# Appendix D. Draft 2023 San Antonio Regional Flood Plan Comments

## **TWDB Draft Plan Comments**

RE: Texas Water Development Board Comments on Region 12 San Antonio RFPG's Draft Regional Flood Plan Contract No. 210792497

## **TWDB Comments on Region 12 San Antonio Regional Flood Planning Group's Draft Regional Flood Plan**

REGION 12 - MAP 16A - FLOOD MANAGEMENT EVALUATIONS  
FINAL

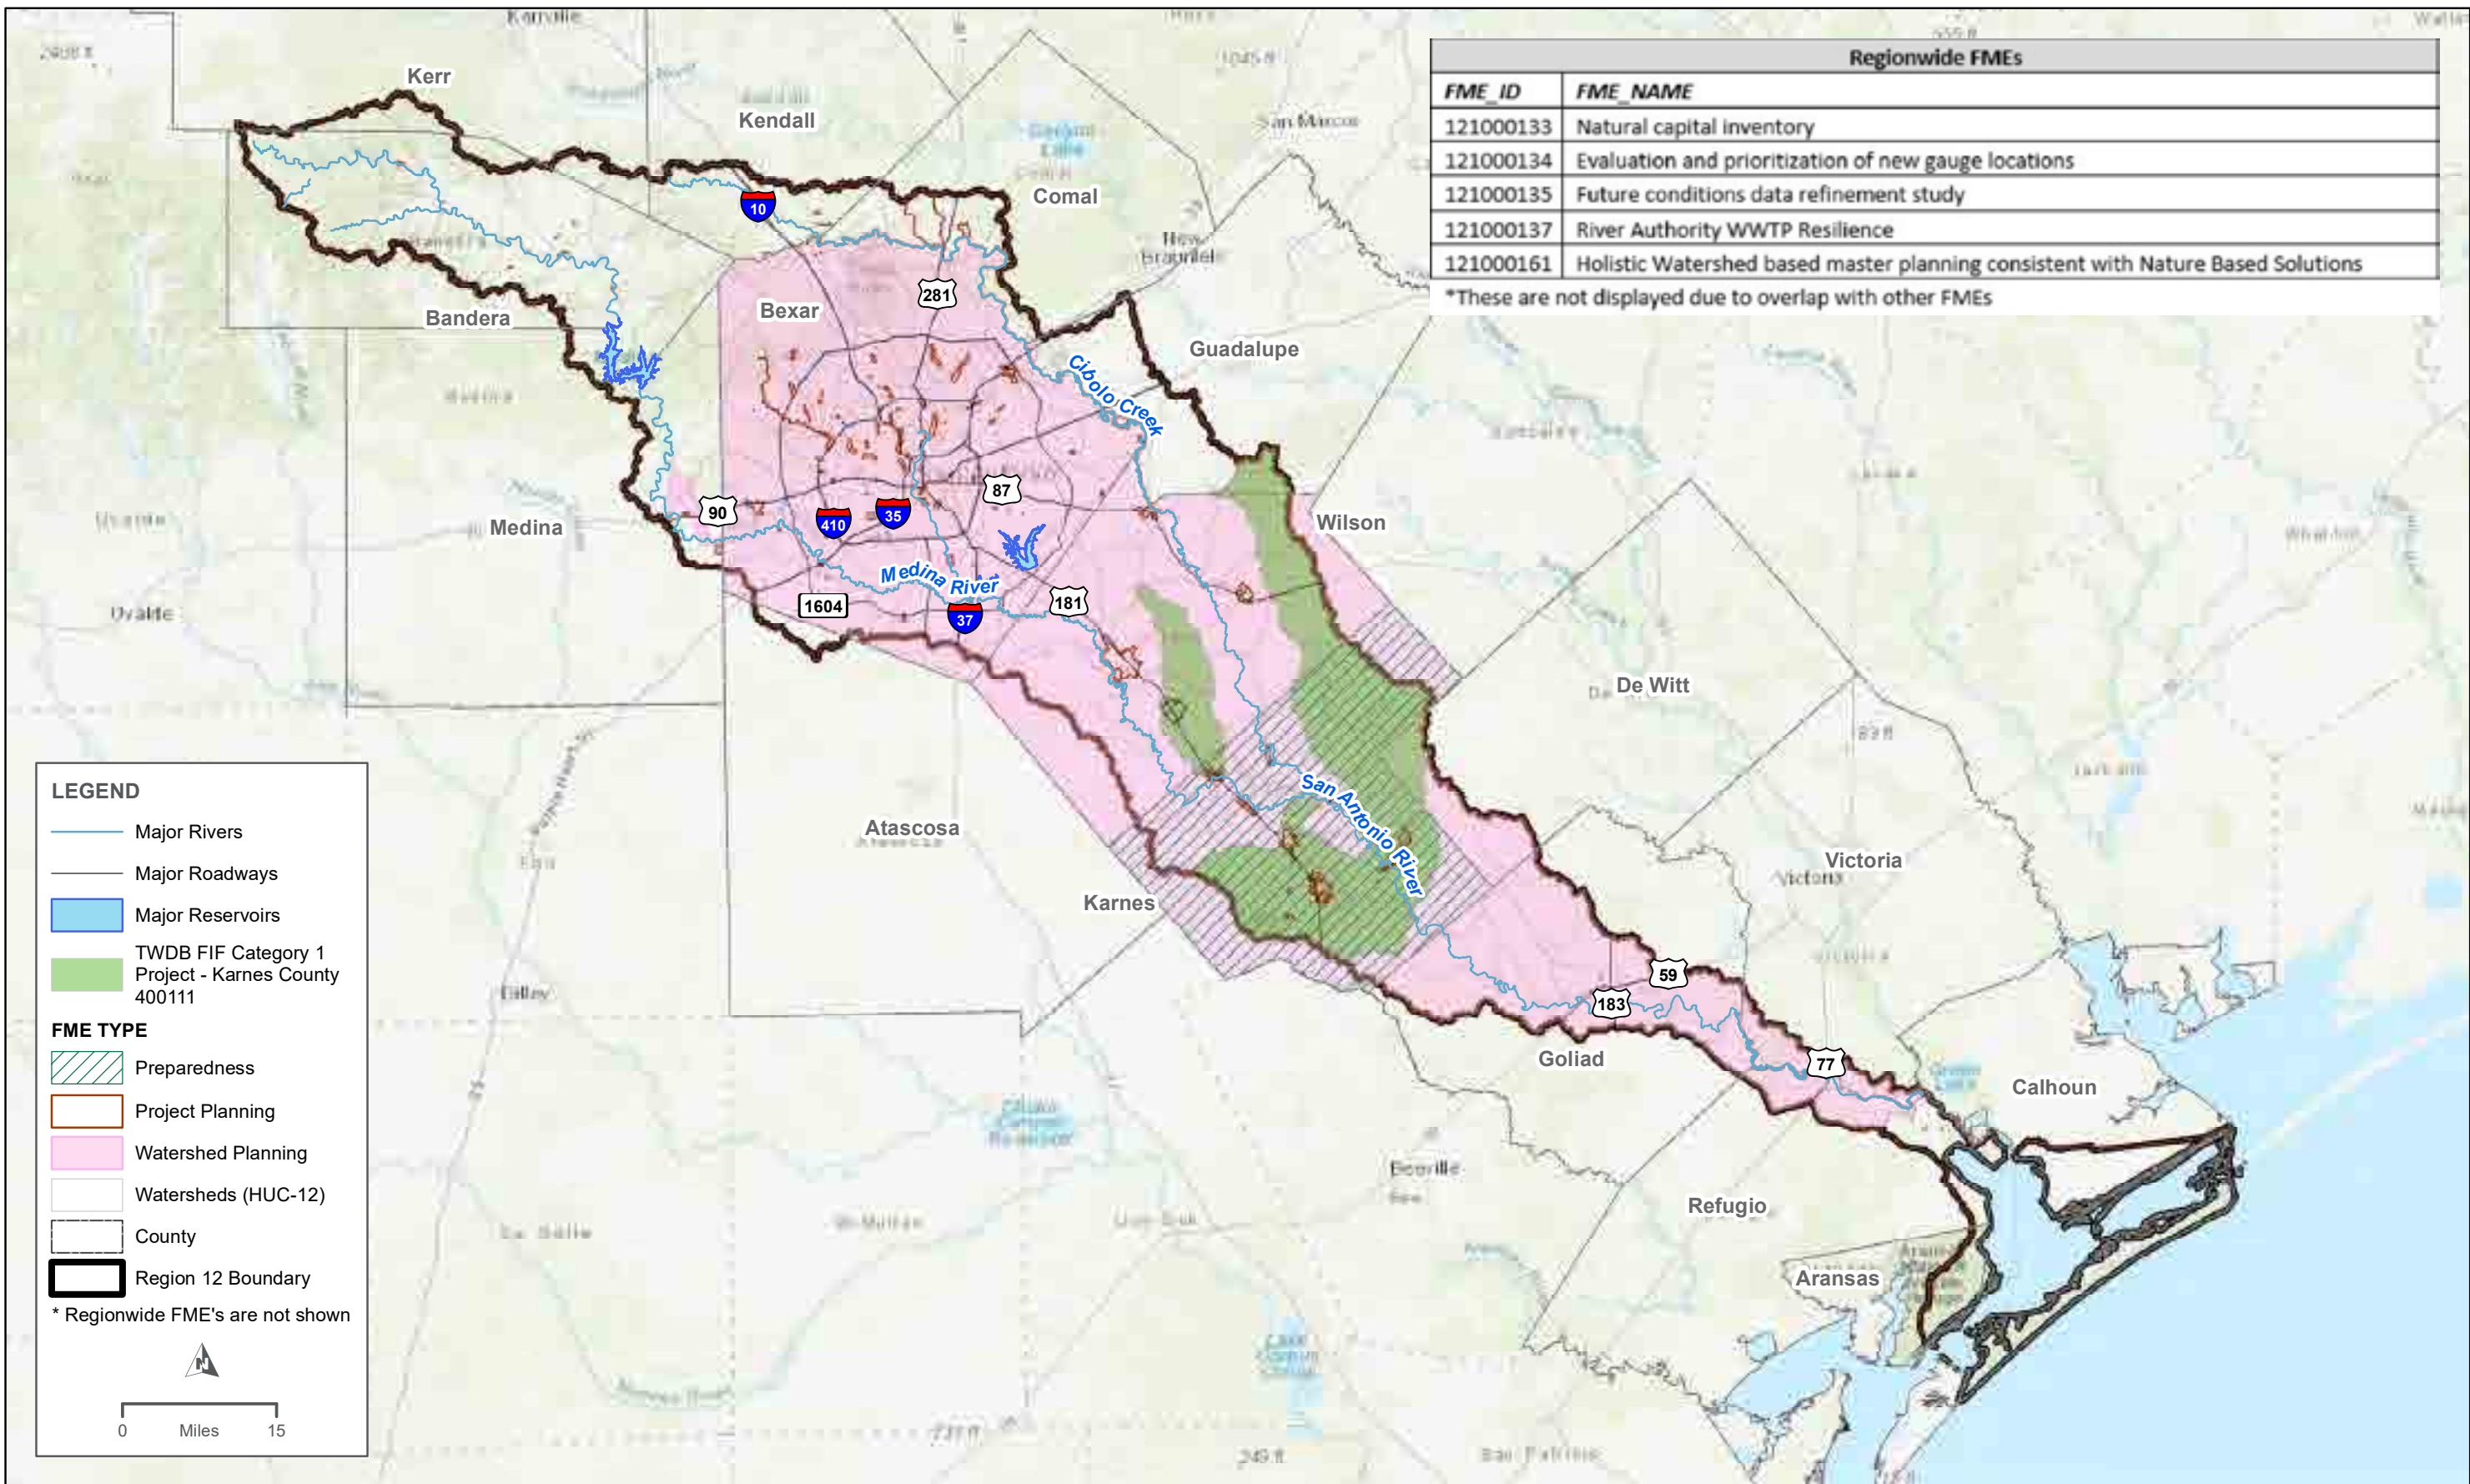
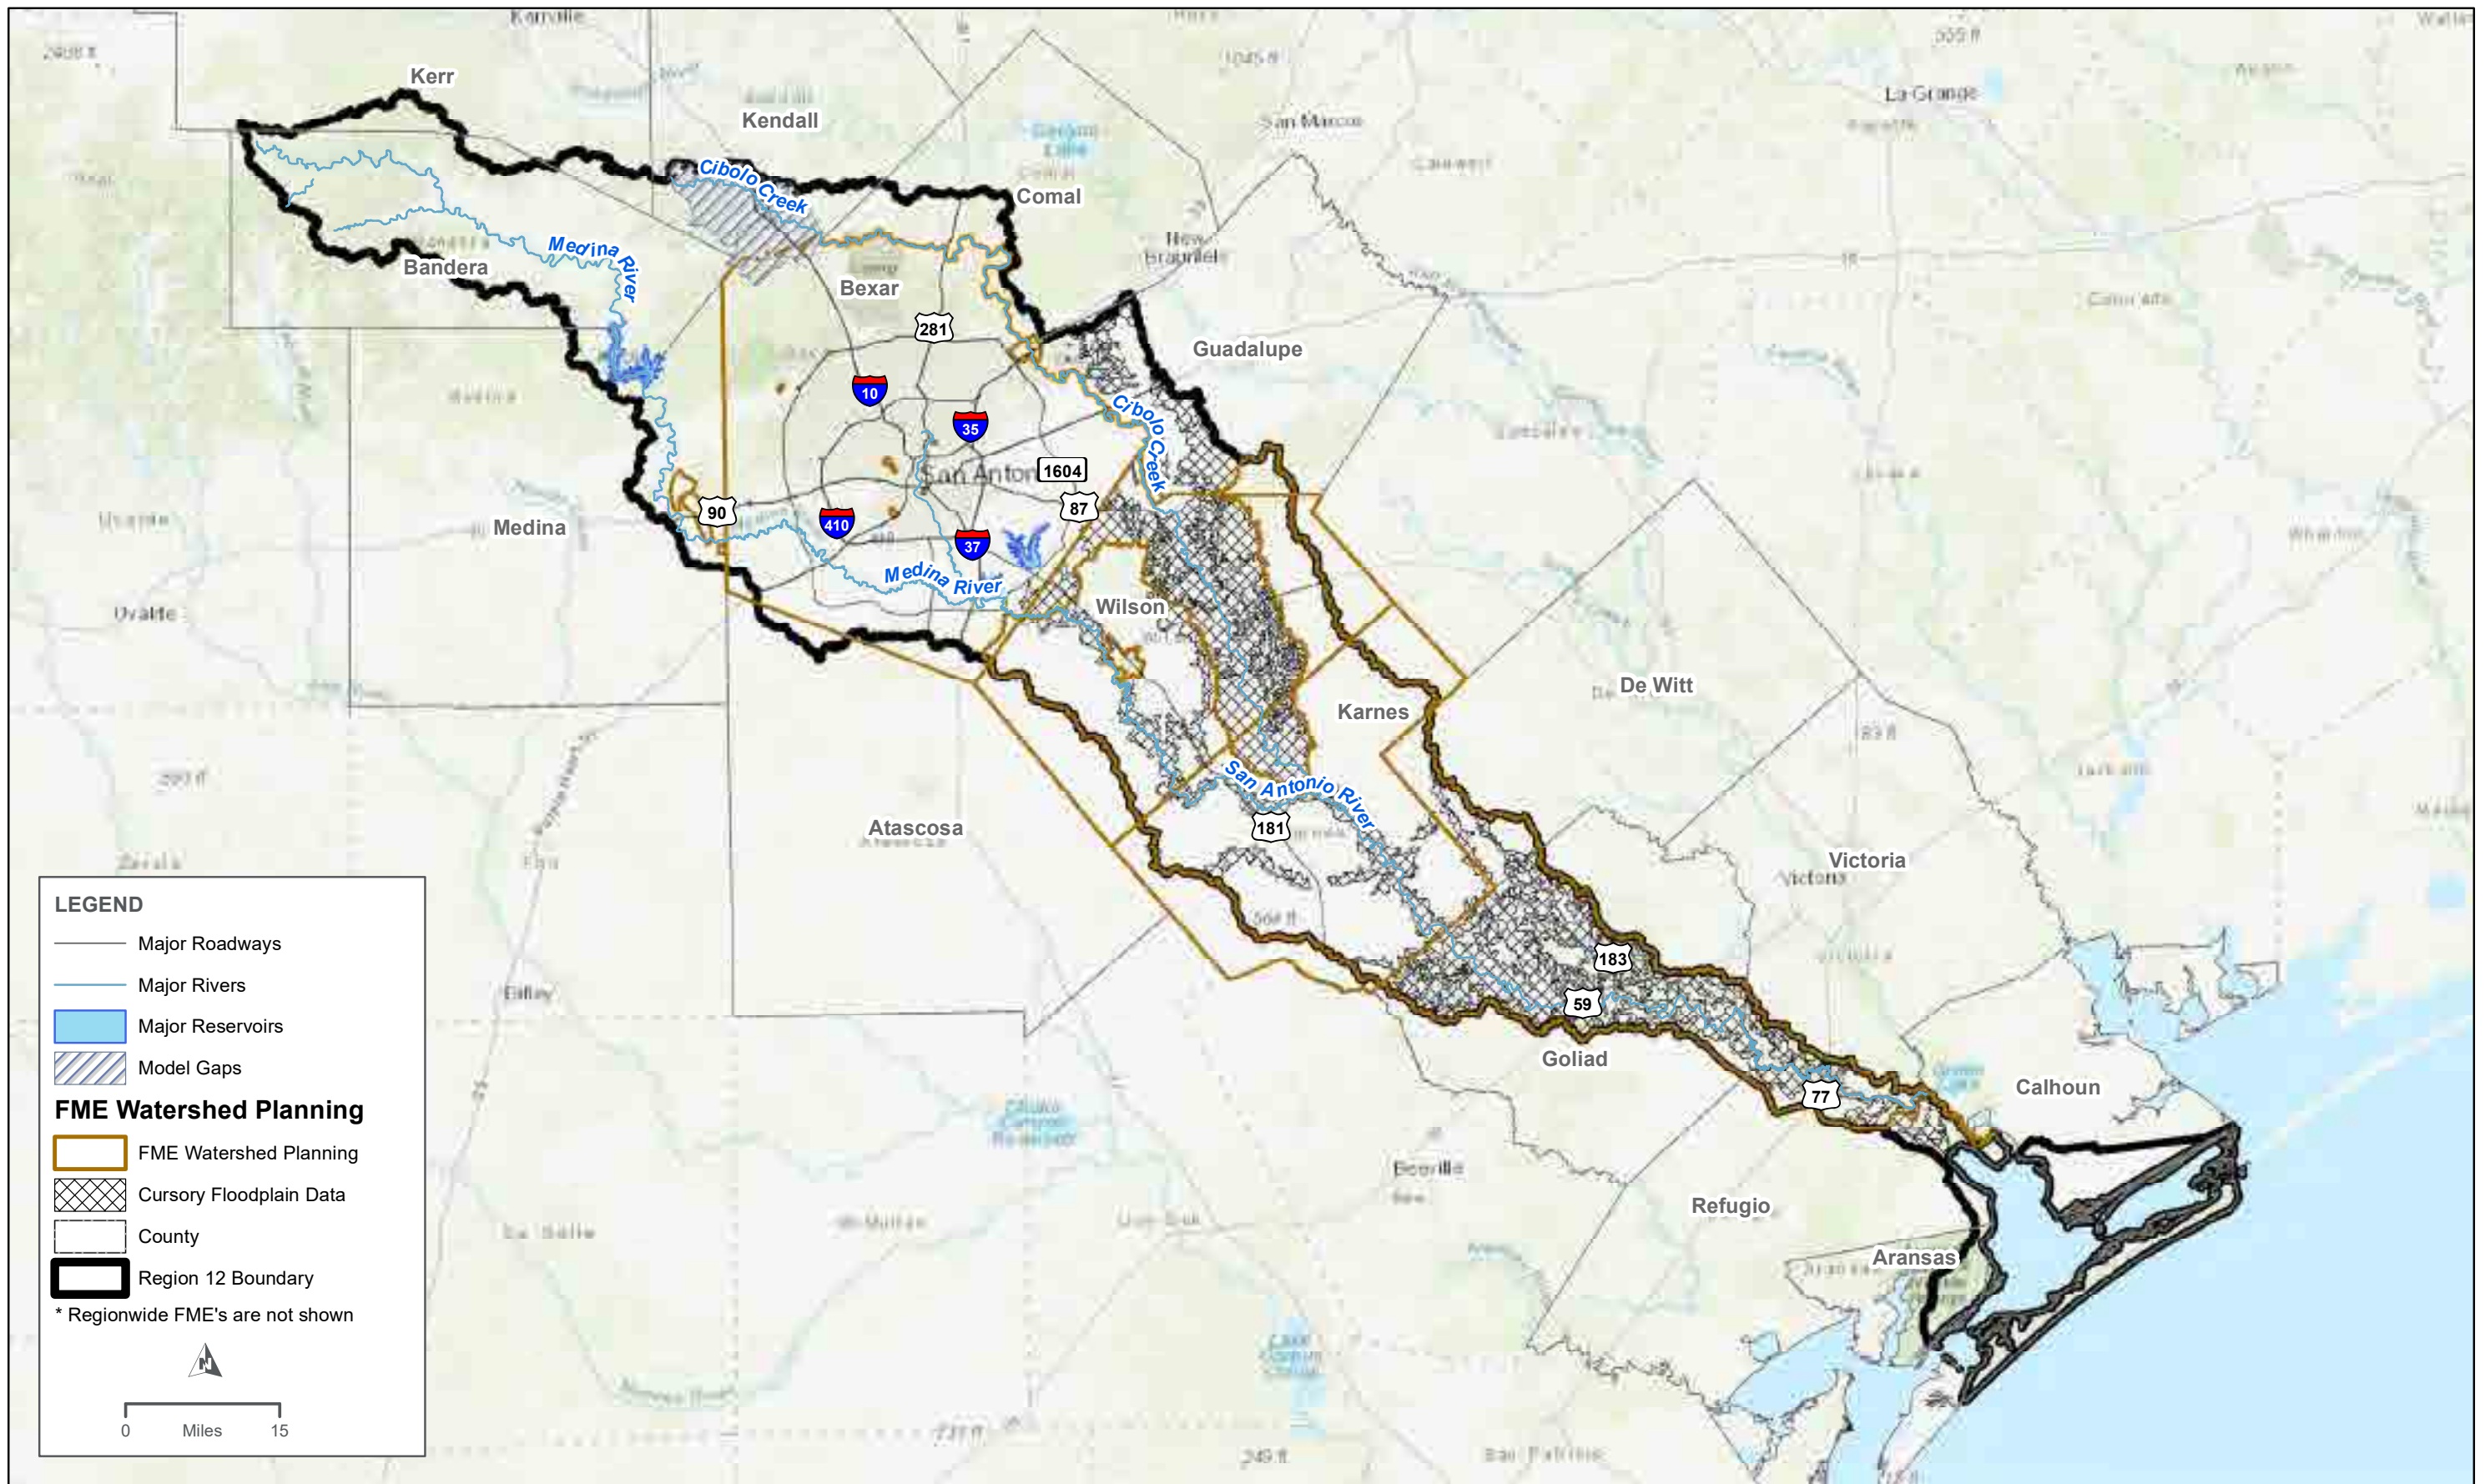
39. Flood Management Evaluation (Exhibit C Map 16):
  - a. Map 16 does not include region-wide FMEs. Please consider providing an additional map that would show all of the FMEs within the region.

Level 1	13	Plan	SOW Task 4B	13.Flood Management Evaluation (Exhibit C Map 16): Please indicate on the map whether the identified FME area is associated with a previously studied area that requires an update or if the identified study area does not have any existing or anticipated flood mapping, models, etc., and therefore requires an initial study. [31 TAC §361.38(m)].	Agree, will update.
